**DESIGN REVIEW APPLICATION |  
REQUEST FOR RESCISSION OF DESIGN EXCEPTION**

Design Review Application **DR-23-01**  
Rescission of HRB Design Exception Request from November 14<sup>th</sup>

DESIGN REVIEW APPLICATION | DESIGN ADJUSTMENTS

Design Review Application **DR-23-01**  
Design Adjustments in Response to  
Comments from June 13<sup>th</sup>, 2023 HRB Meeting

2 SECOND FLOOR PLAN + EAST & 12th STREET ELEVATIONS

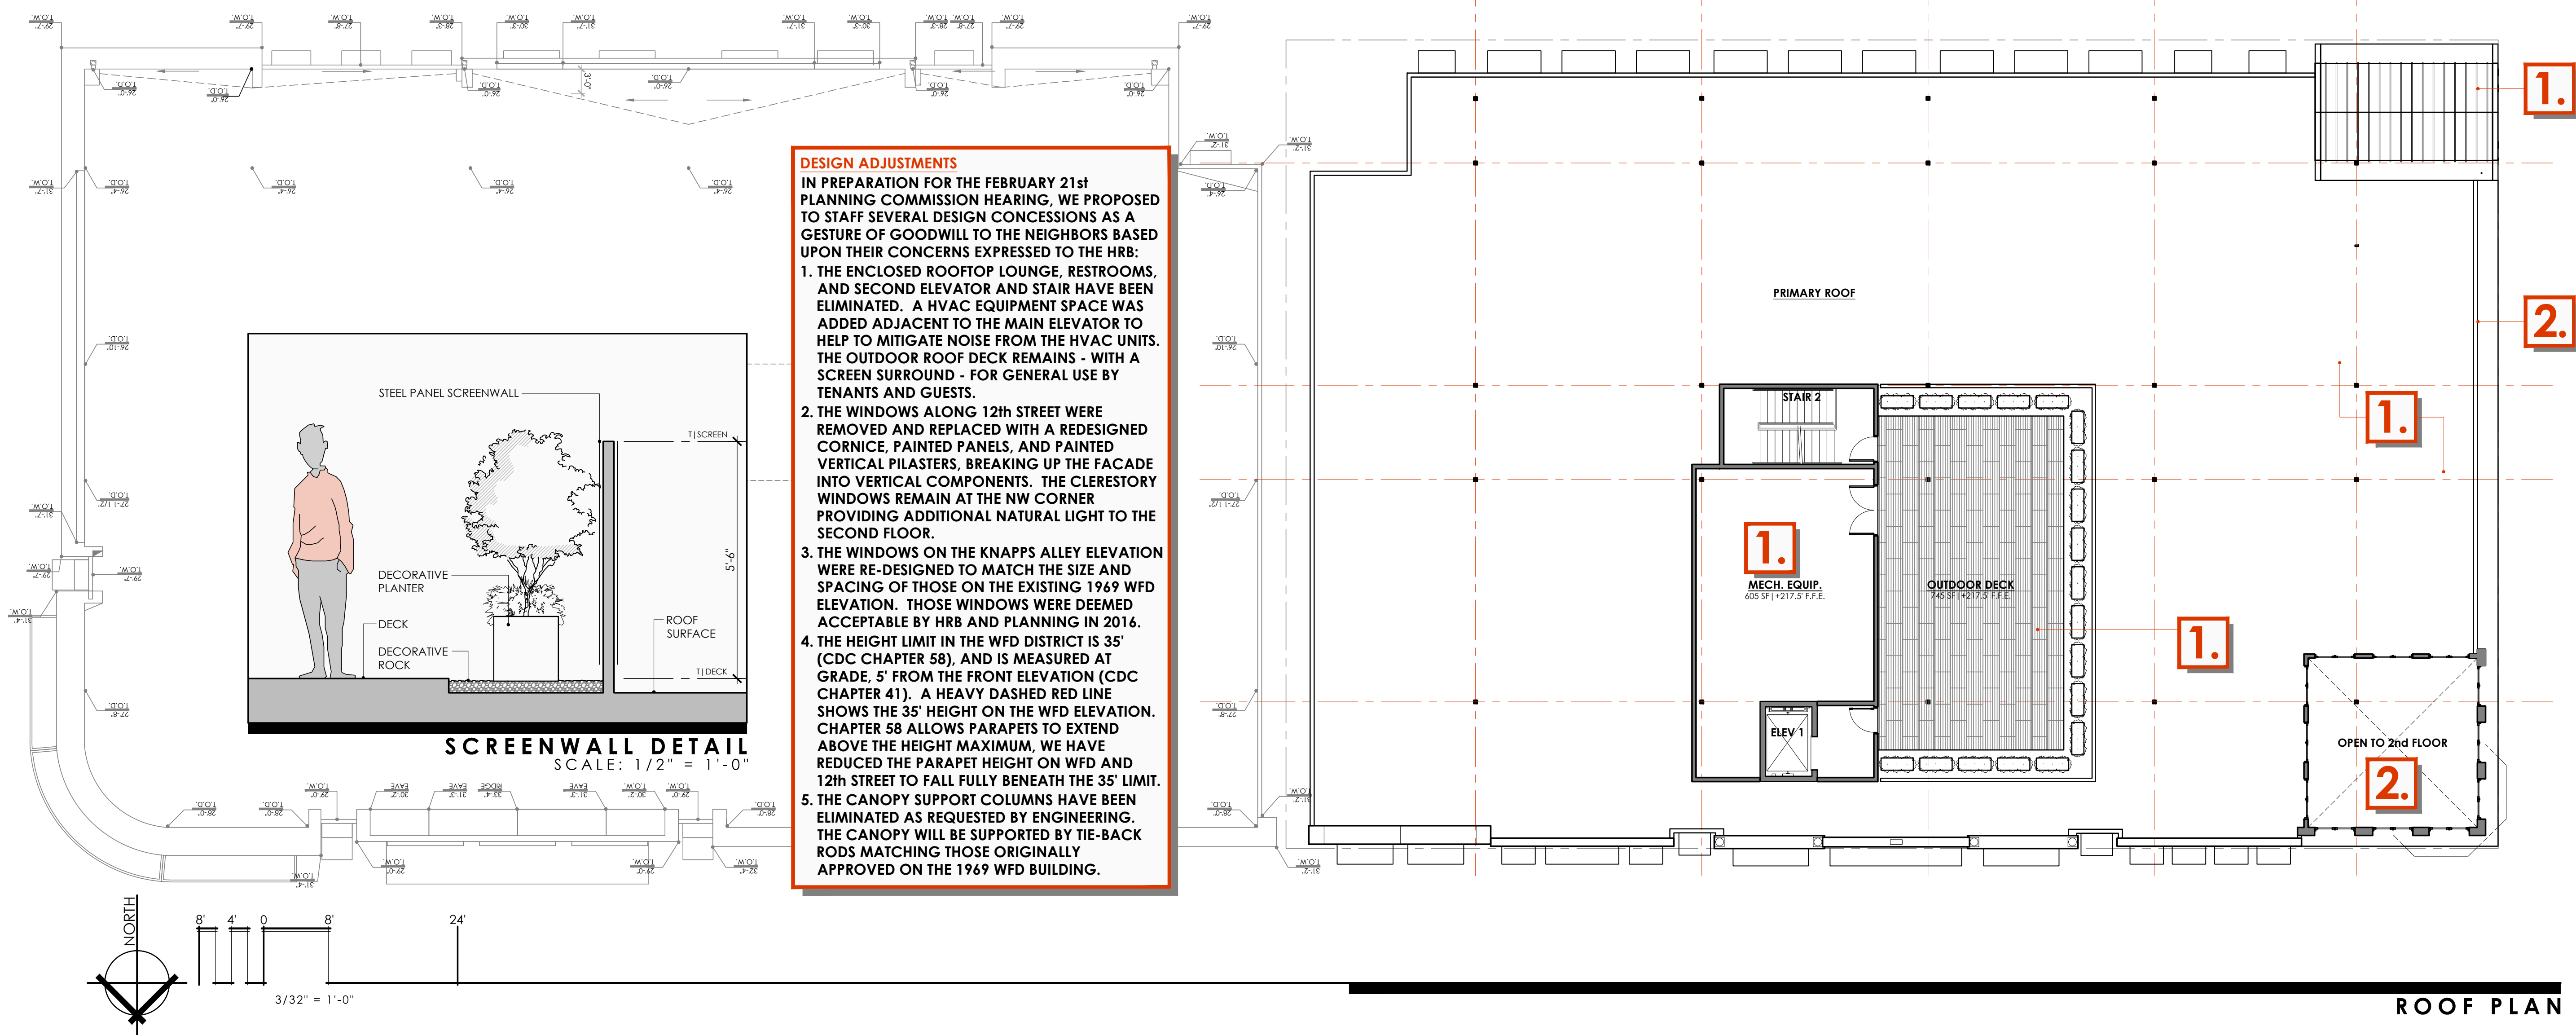
1. *CONCERN: While the IBC does not consider a mezzanine to be a separate floor, the HRB was not clear if the Willamette Falls Drive Commercial Design District Code (Chapter 58) (WFDCD) would allow for a mezzanine level above the second floor as shown in the 6/13 presentation. Further, the upper row of windows along 12<sup>th</sup> Street in the original presentation was seen by some as an indication of a 3<sup>rd</sup> floor that would not be permitted under the standards.*

- **The windows along 12th street have been removed and replaced with a redesigned cornice, painted panels, and painted vertical pilasters, breaking up the facade into vertical components. The clerestory windows remain at the corner providing additional natural light to the second floor.**
- **The enclosed rooftop lounge, restrooms, second elevator, and stair have been eliminated.**
- **A HVAC equipment space was added adjacent to the main elevator to help to mitigate noise from the units.**
- **The outdoor roof deck remains for general use by tenants and guests - with a screen surround to reduce potential noise and light issues for our residential neighbors.**

2. THE WINDOWS ALONG 12th STREET WERE REMOVED AND REPLACED WITH A REDESIGNED CORNICE, PAINTED PANELS, AND PAINTED VERTICAL PILASTERS, BREAKING UP THE FACADE INTO VERTICAL COMPONENTS. THE CLERESTORY WINDOWS REMAIN AT THE NW CORNER PROVIDING ADDITIONAL NATURAL LIGHT TO THE SECOND FLOOR.

**3** ROOF PLAN + KNAPPS ALLEY ELEVATION

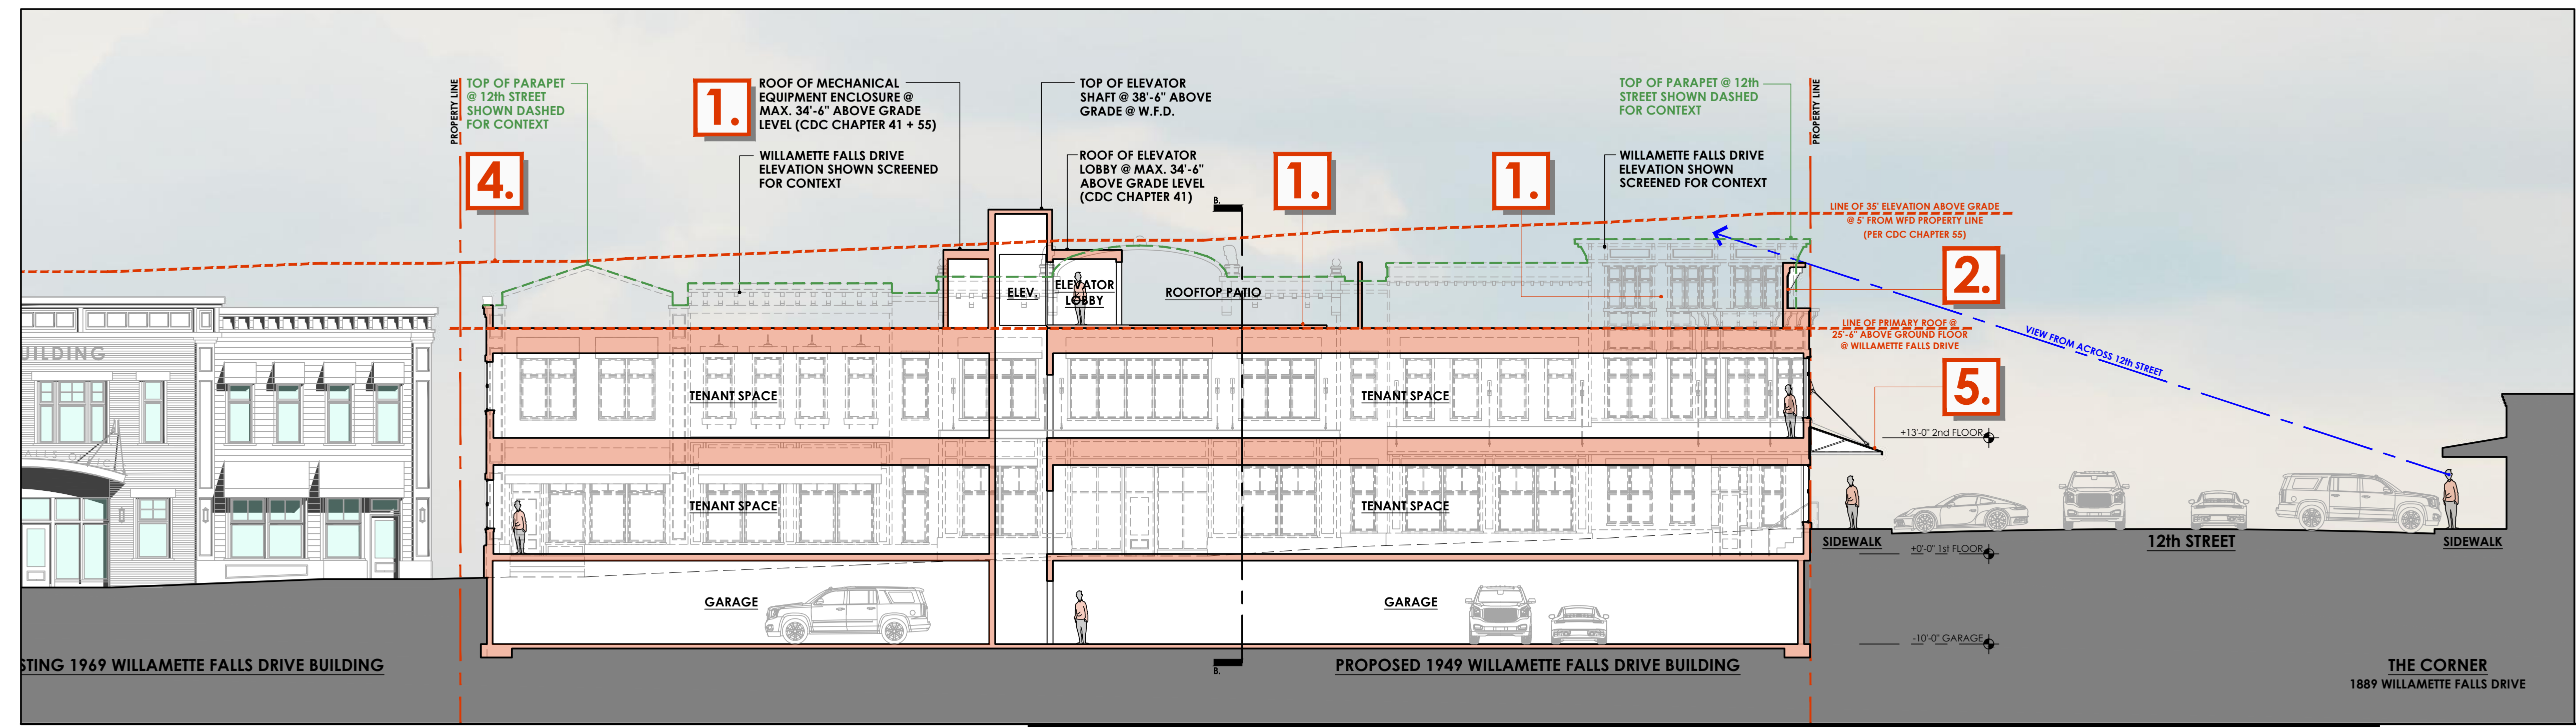
2. CONCERN: There was concern from the residential neighbors across Knapps Alley that the 2<sup>nd</sup> floor windows on the alley elevation were too large.

- The windows along the Knapps Alley elevation have been re-designed to match the size and spacing of those on the existing building (1969 Willamette Falls Drive). Those windows were found by the HRB and these same neighbors to be acceptable during the HRB and Planning Commission review for the 1969 building.
3. CONCERN: The Board was concerned that the drawing showing the Willamette Falls Drive elevation did not show clearly enough that the building elevation meets the 35' height limit required by the Standards. Per Section 41.005 "Determining Height of Building" and Section 58.080.C.3 of the WFDCD:

3. THE WINDOWS ON THE KNAPPS ALLEY ELEVATION WERE RE-DESIGNED TO MATCH THE SIZE AND SPACING OF THOSE ON THE EXISTING 1969 WFD ELEVATION. THOSE WINDOWS WERE DEEMED ACCEPTABLE BY HRB AND PLANNING IN 2016.

4 SITE SECTIONS | VIEWS FROM ADJACENT LOTS

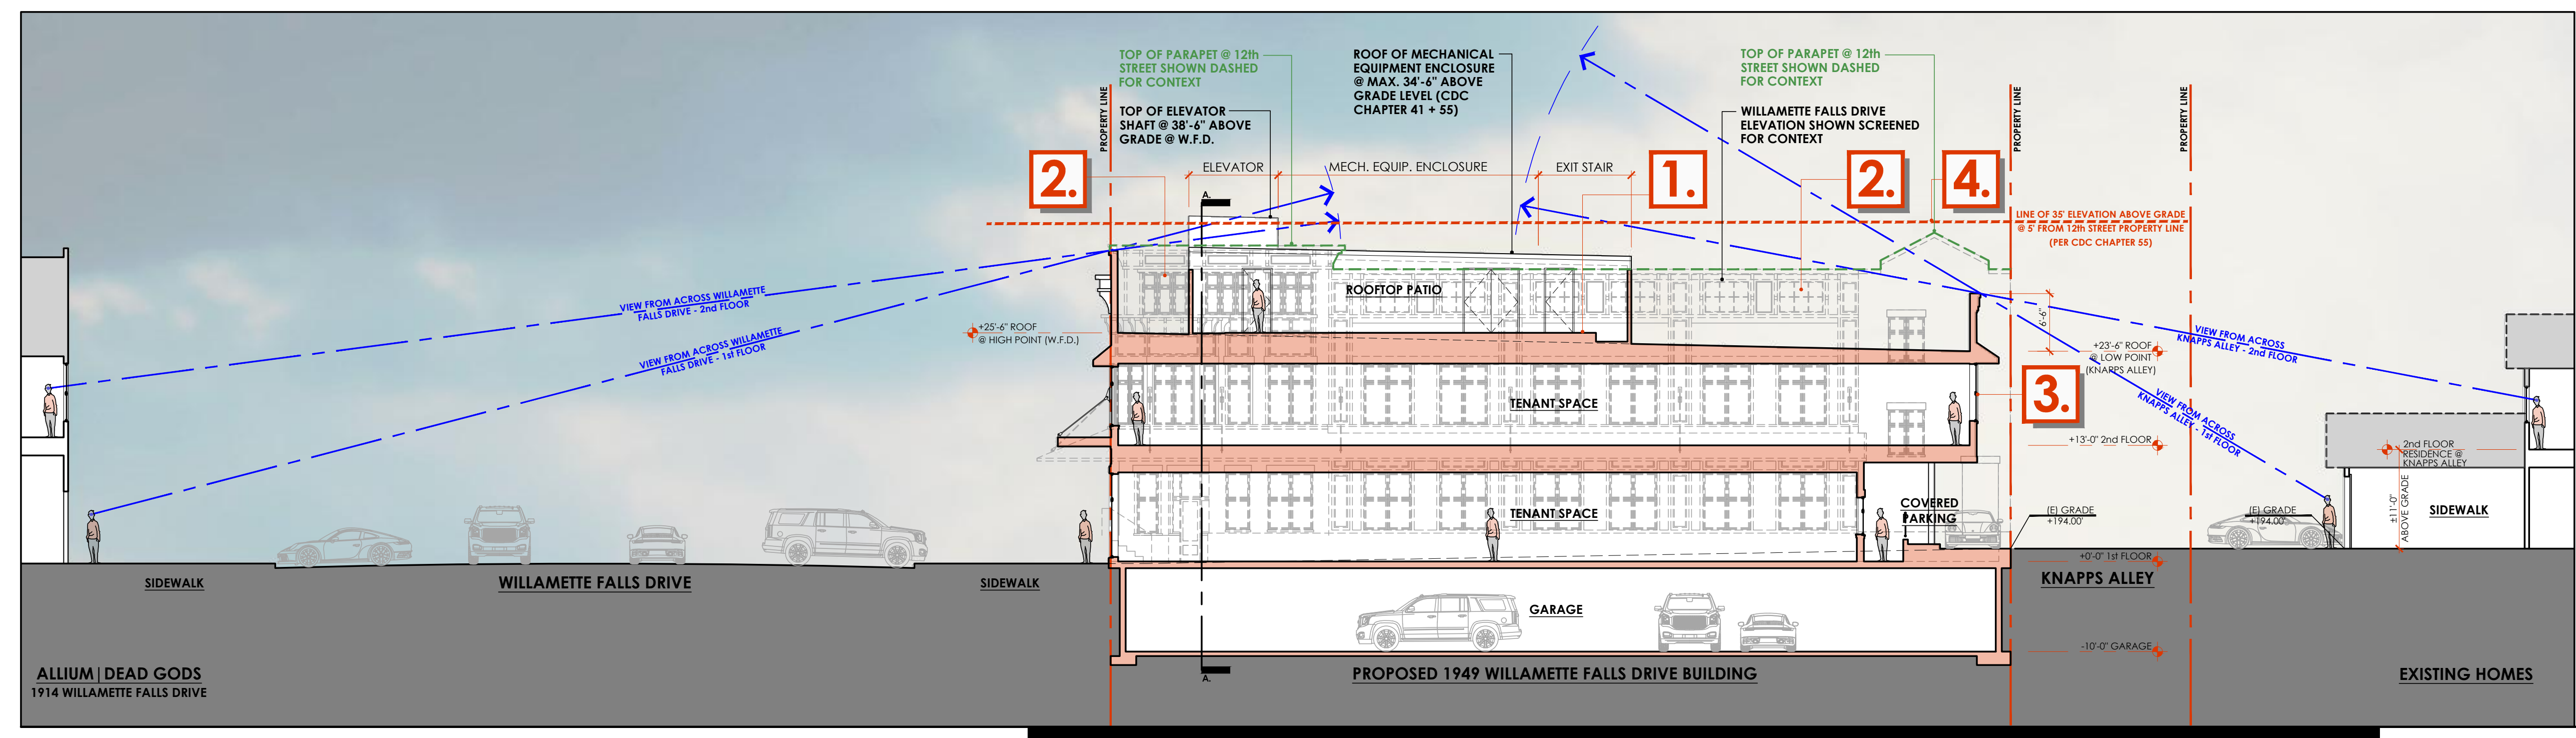
IN PREPARATION FOR THE FEBRUARY 21st PLANNING COMMISSION HEARING, WE PROPOSED TO STAFF SEVERAL DESIGN CONCESSIONS AS A GESTURE OF GOODWILL TO THE NEIGHBORS BASED UPON THEIR CONCERNS EXPRESSED TO THE HRB:

1. THE ENCLOSED ROOFTOP LOUNGE, RESTROOMS, AND SECOND ELEVATOR AND STAIR HAVE BEEN ELIMINATED. A HVAC EQUIPMENT SPACE WAS ADDED ADJACENT TO THE MAIN ELEVATOR TO HELP TO MITIGATE NOISE FROM THE HVAC UNITS. THE OUTDOOR ROOF DECK REMAINS - WITH A SCREEN SURROUND - FOR GENERAL USE BY TENANTS AND GUESTS.

4. THE HEIGHT LIMIT IN THE WFD DISTRICT IS 35' (CDC CHAPTER 58), AND IS MEASURED AT GRADE, 5' FROM THE FRONT ELEVATION (CDC CHAPTER 41). A HEAVY DASHED RED LINE SHOWS THE 35' HEIGHT ON THE WFD ELEVATION. CHAPTER 58 ALLOWS PARAPETS TO EXTEND ABOVE THE HEIGHT MAXIMUM, WE HAVE REDUCED THE PARAPET HEIGHT ON WFD AND 12th STREET TO FALL FULLY BENEATH THE 35' LIMIT.
